Santa Ynez Community Services District
1070 Faraday Street
P.O. Box 667
Santa Ynez, CA 93460

The undersigned, as bidder, declares that it has received and examined the documents entitled Santa Ynez Community Services District Horizon Sewer Project, SYCSD Project No. 2021-01 and will contract with the Owner, on the form of Agreement provided herewith, to do everything required for the fulfillment of the contract for the construction of the project at the prices and on the terms and conditions herein contained.

BID SCHEDULE, SYCSD PROJECT NO. 2021-01

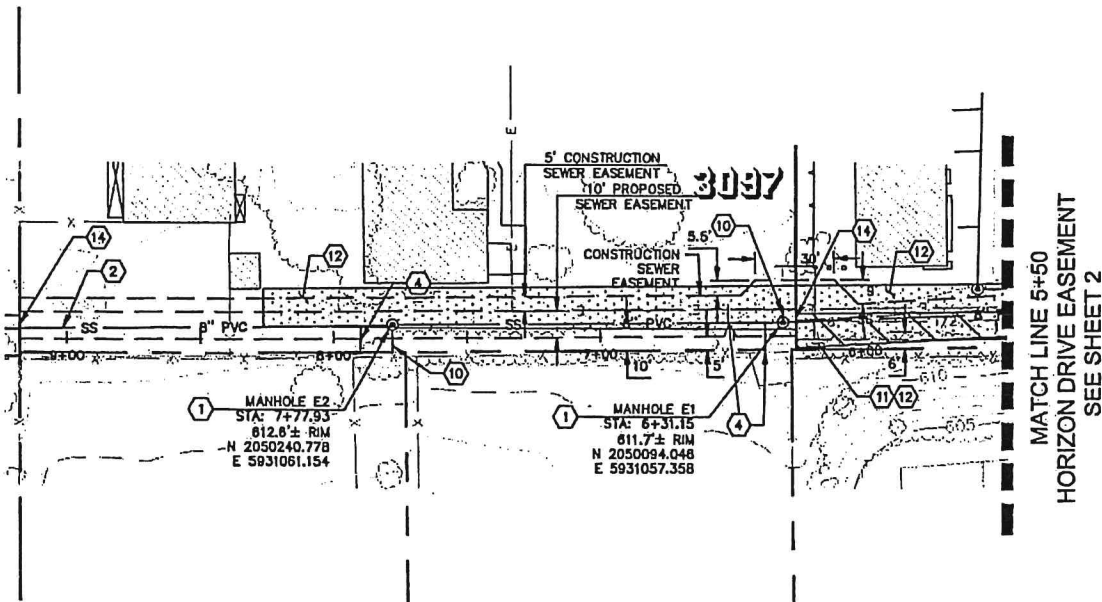
14. Question: Can the District supply a Soils Compaction Testing Requirements spelled out in writing so all the contractors are bidding apples to apples.

Answer: All trench backfill shall be compacted to a minimum relative compaction of 90%. The top 2 1/2 feet of the trench within roadbed areas shall be compacted in horizontal layers not exceeding 8 inches in thickness, and compacted to 95%. The specific compaction testing requirements during construction will be per the conditions called out in the SBCO Encroachment Permit.
